FORESTSIDE TOWNHOUSES

SITE INSTRUCTION # 3

Date: May 7th, 2021

JAP Project No: 19066

Sheet Title:
P1 UNDERGROUND WEST AREA

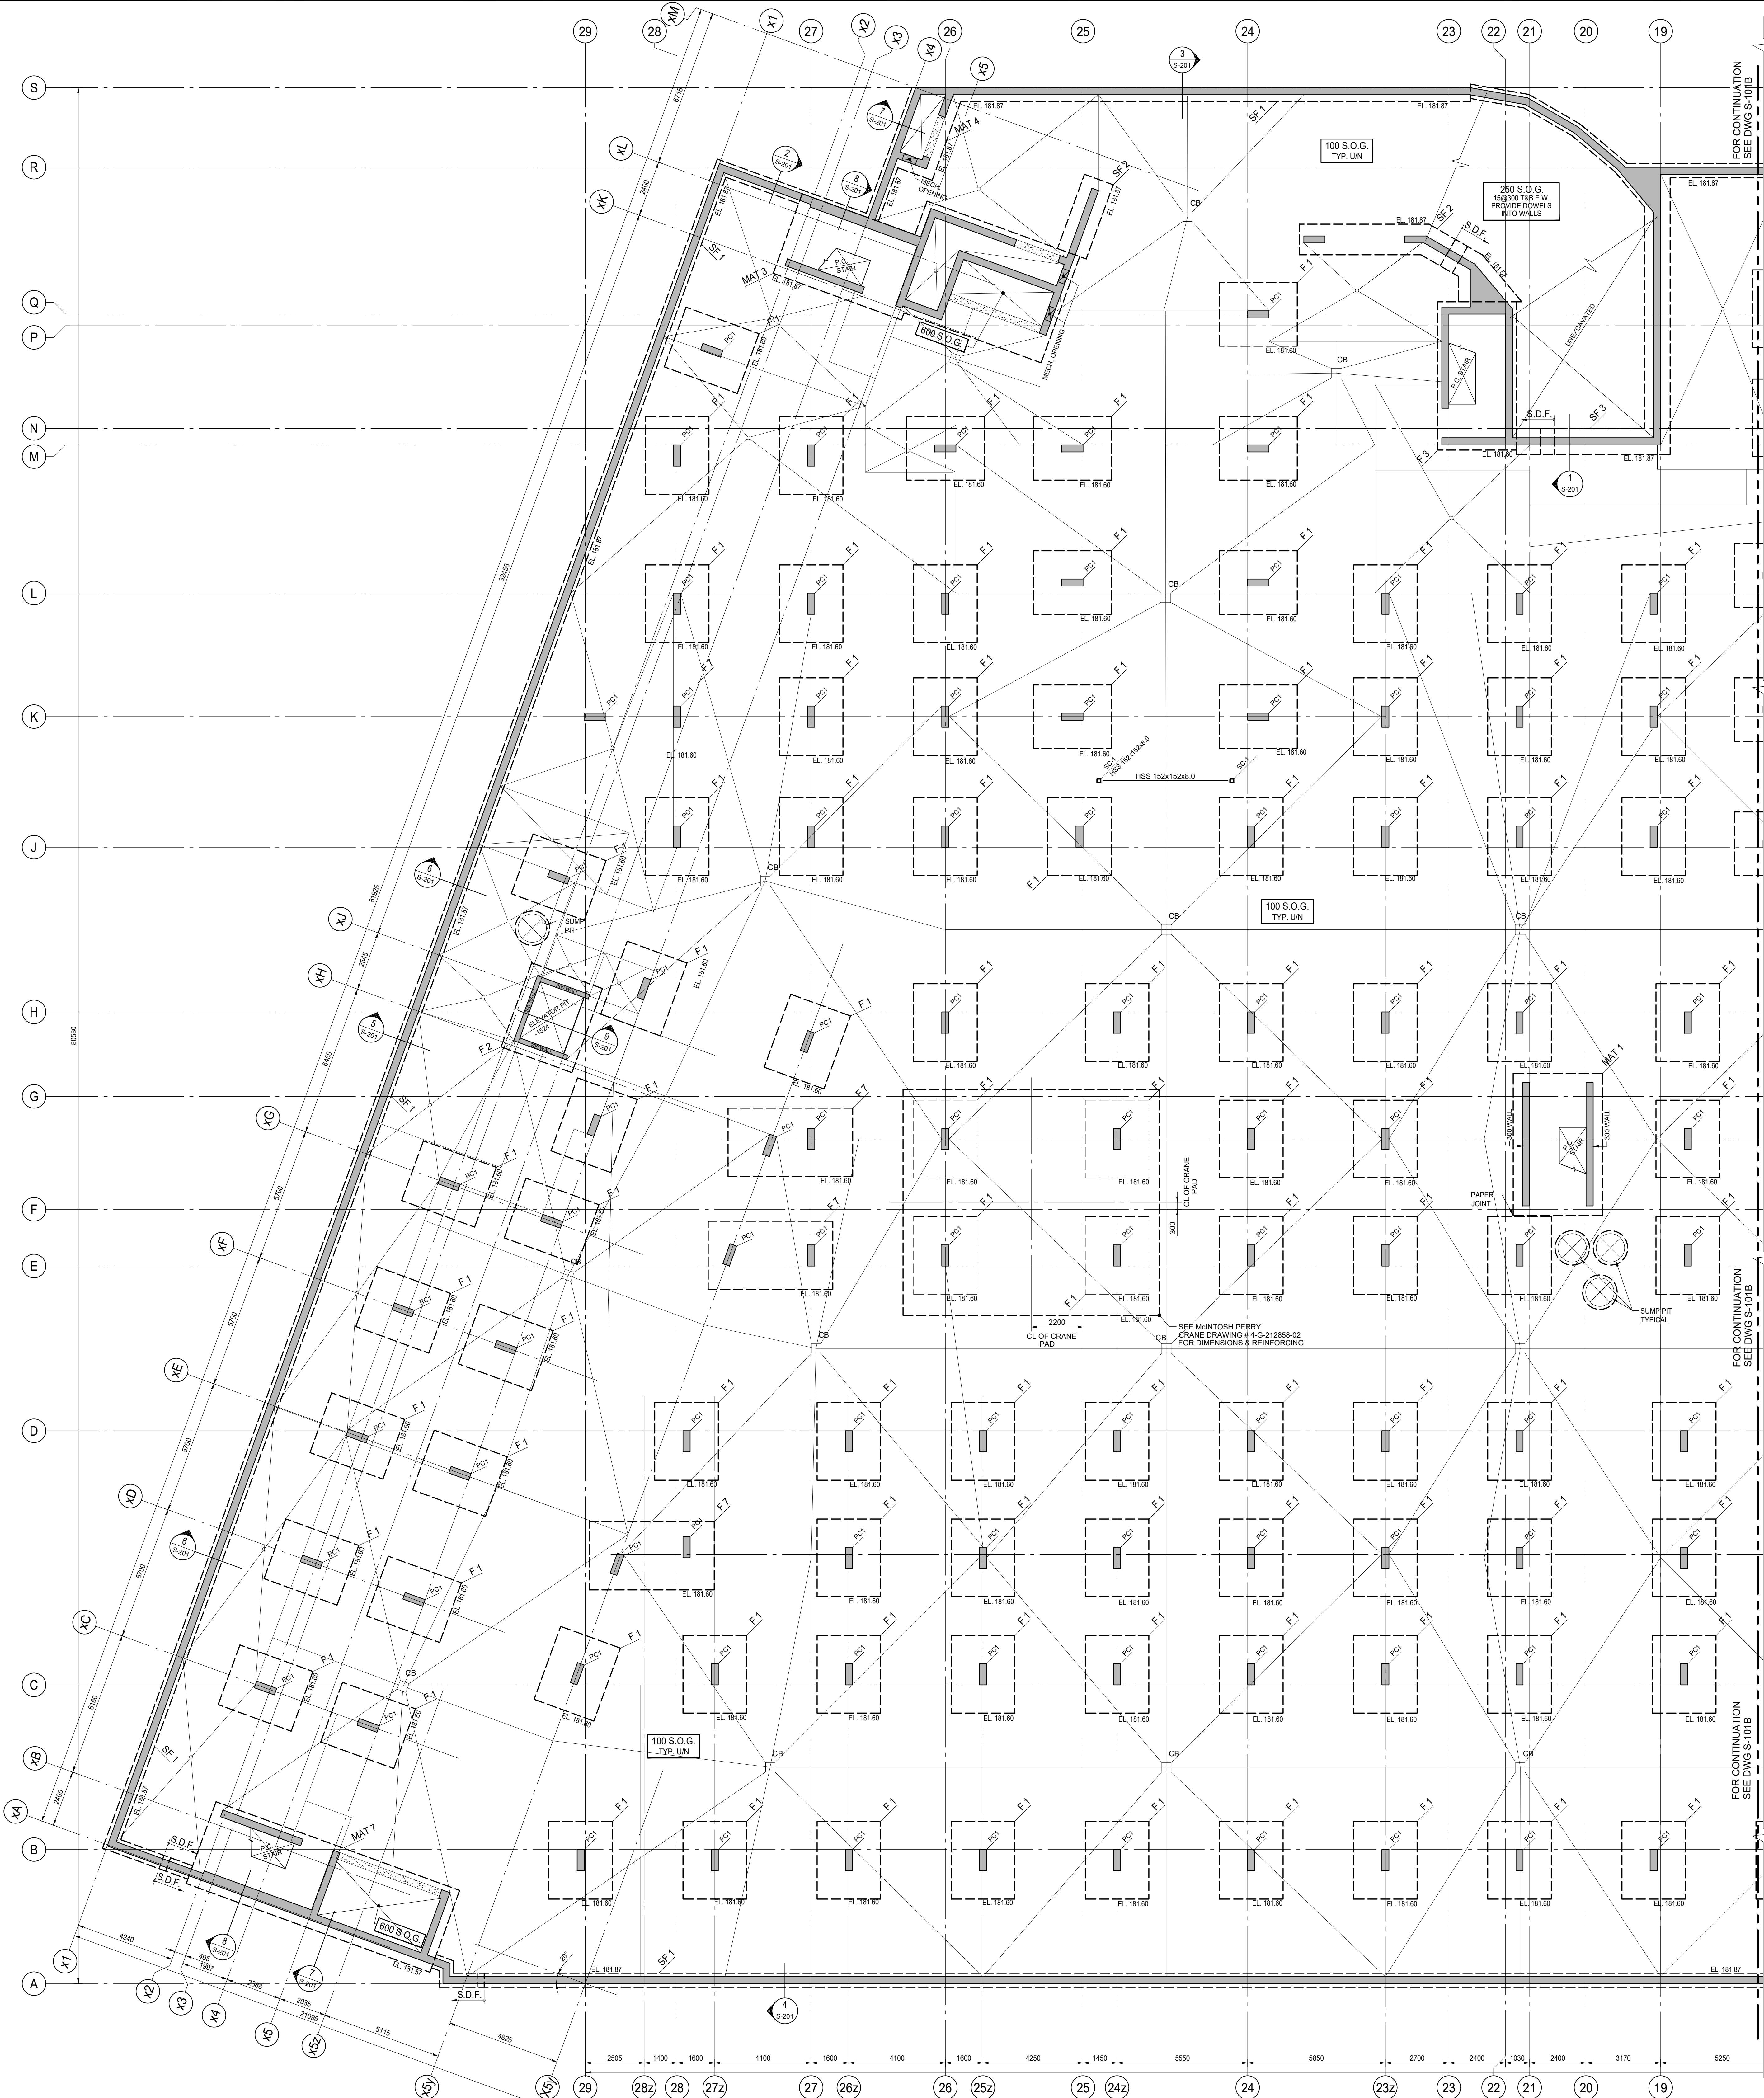
1.1 **Refer to Drawing S-101A & B "P1 UNDERGROUND"**

- a) Updated footing elevations
- b) Updated concrete strengths

1ST FLOOR
BUILDING D

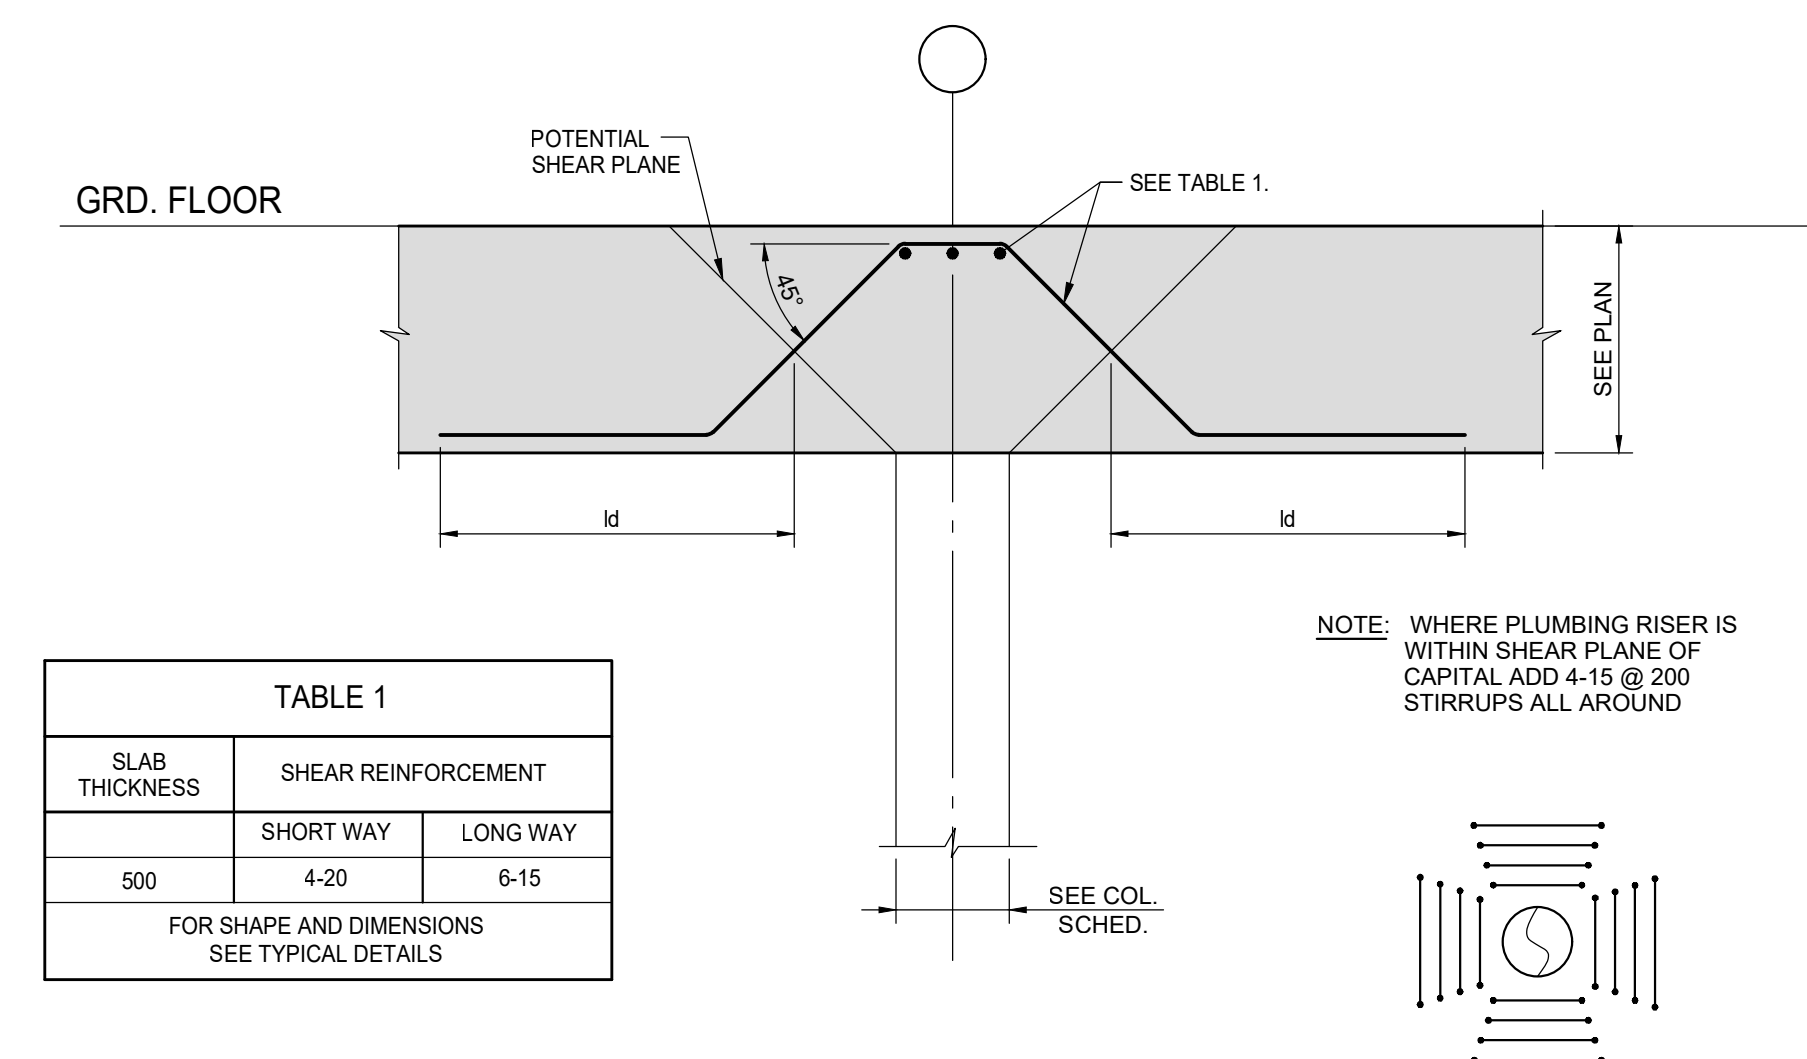
1.2 **Refer to Drawing S-102A & B "GROUND FLOOR FRAMING"**

- c) Updated to match latest slab edge
- d) Updated footing elevations
- e) Updated concrete strengths

Sheet Title:
**2ND FLOOR
BUILDING D**

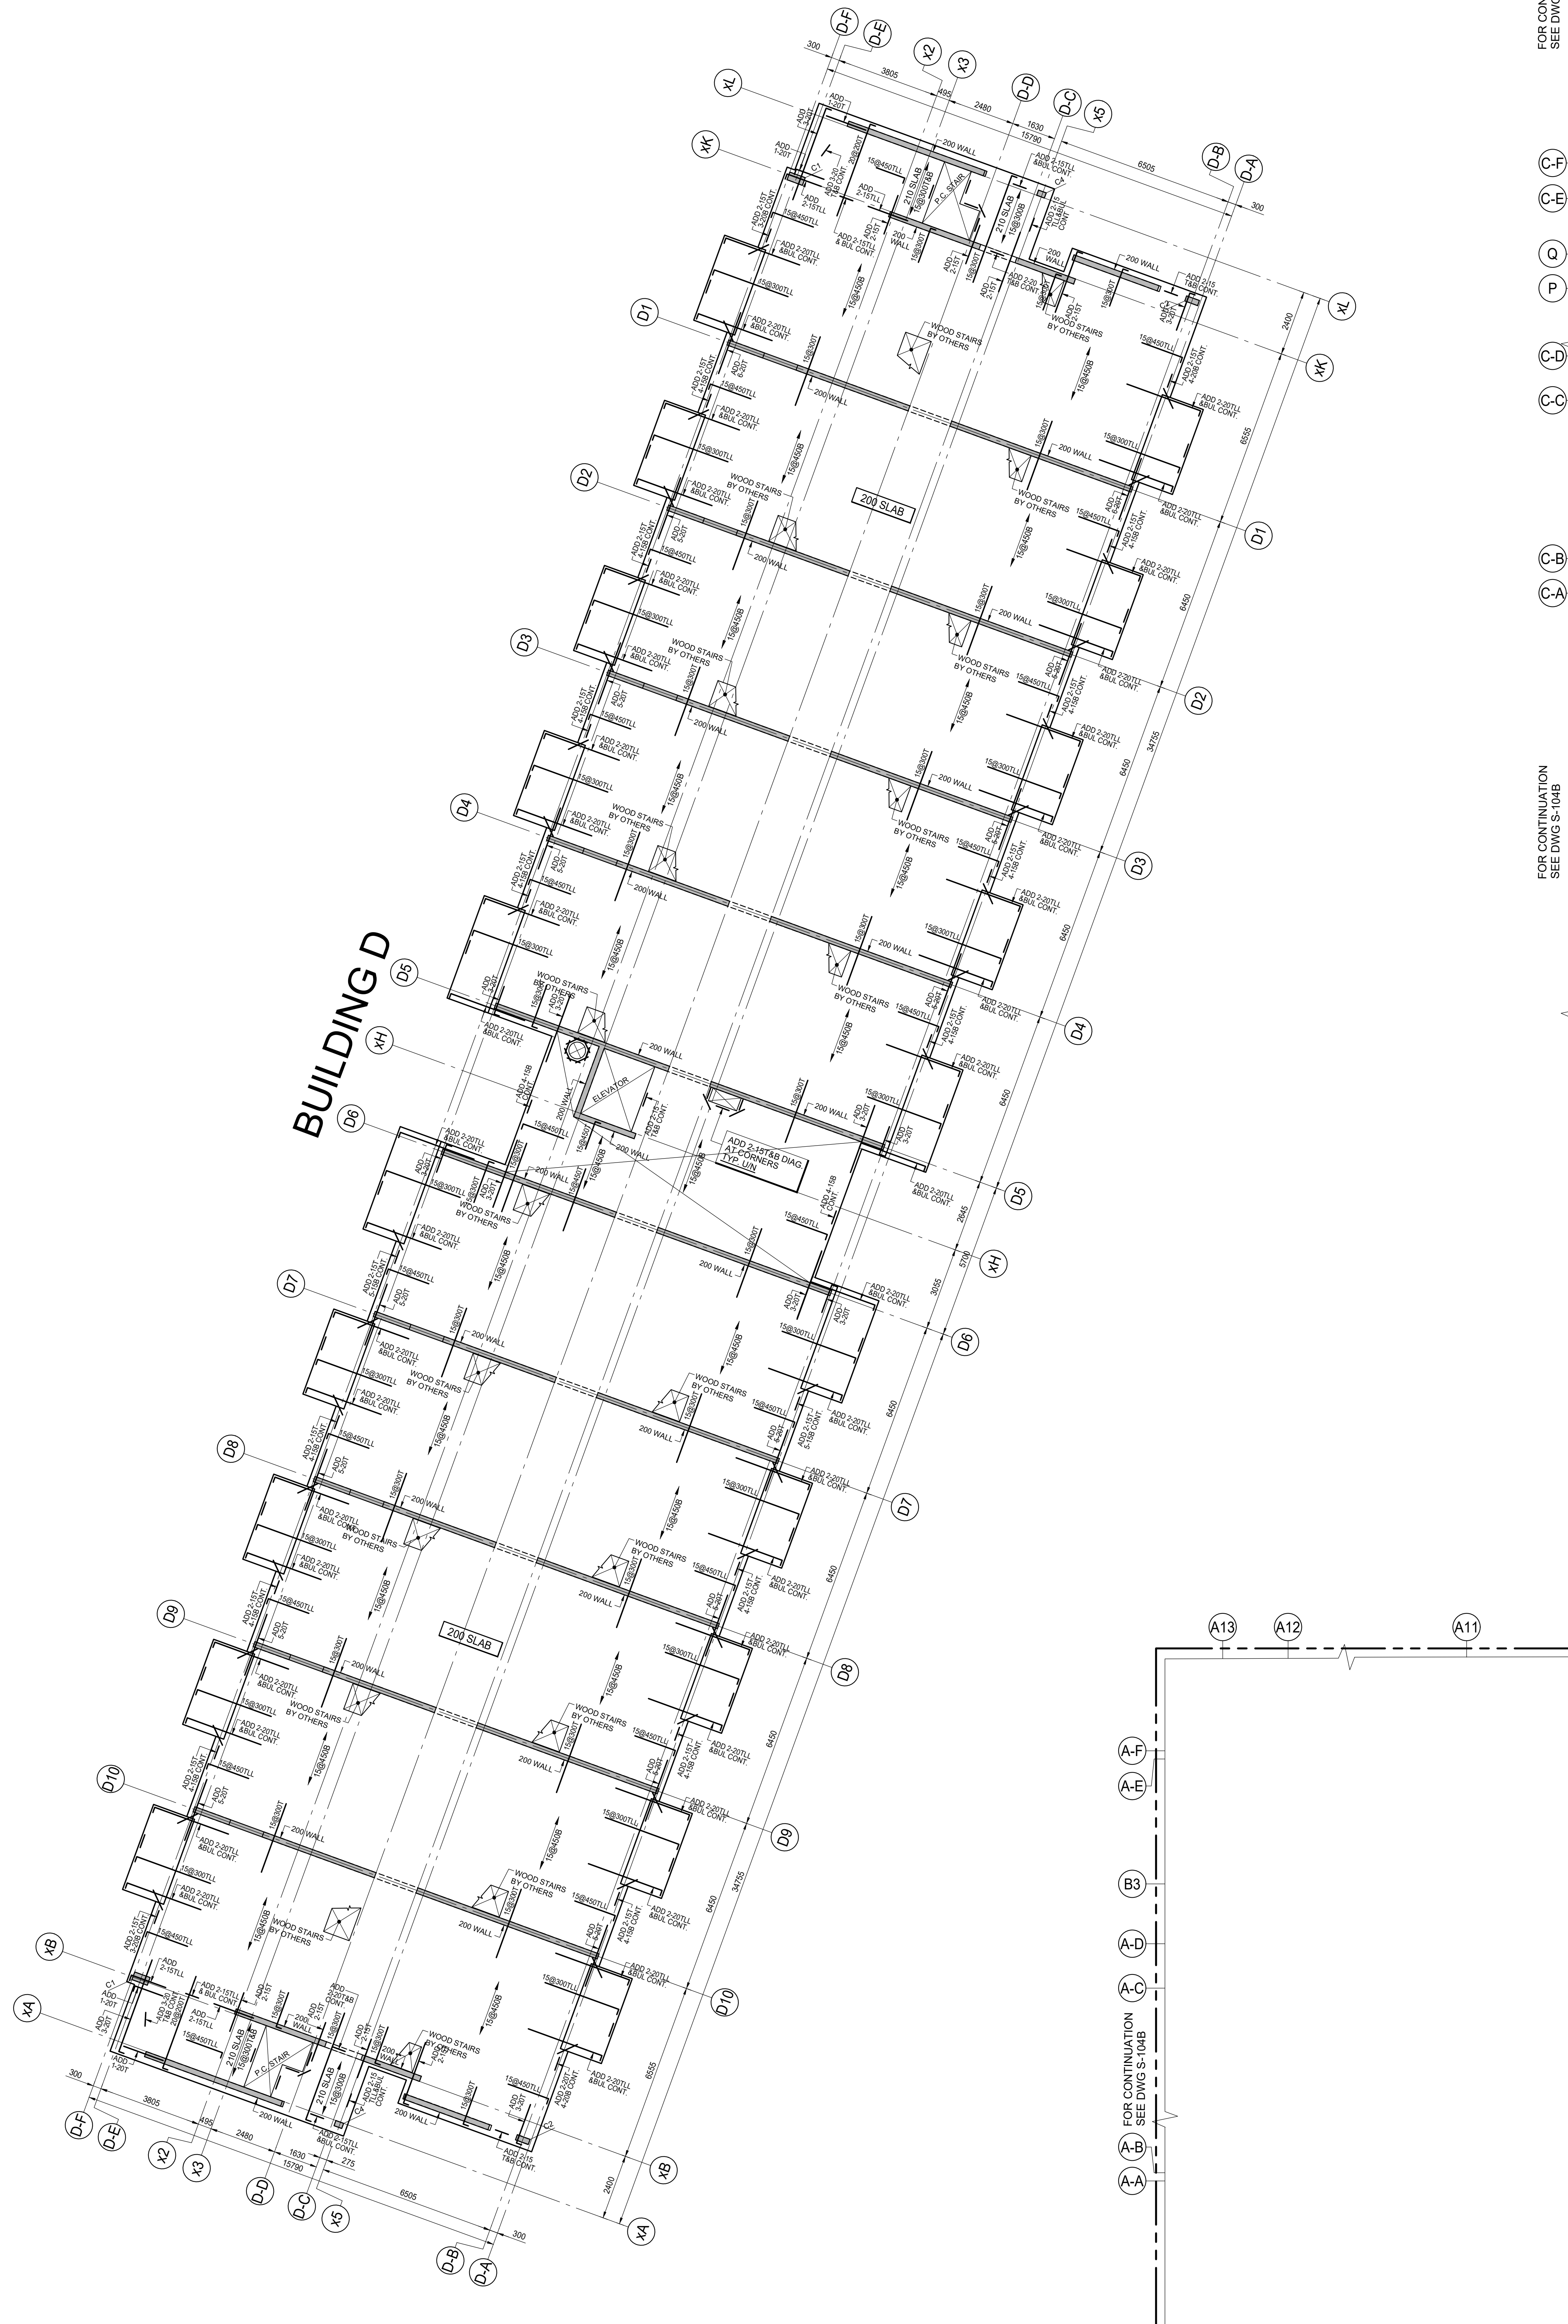
1.3 **Refer to Drawing S-103A "2nd FLOOR FRAMING"**

- f) Updated concrete strengths
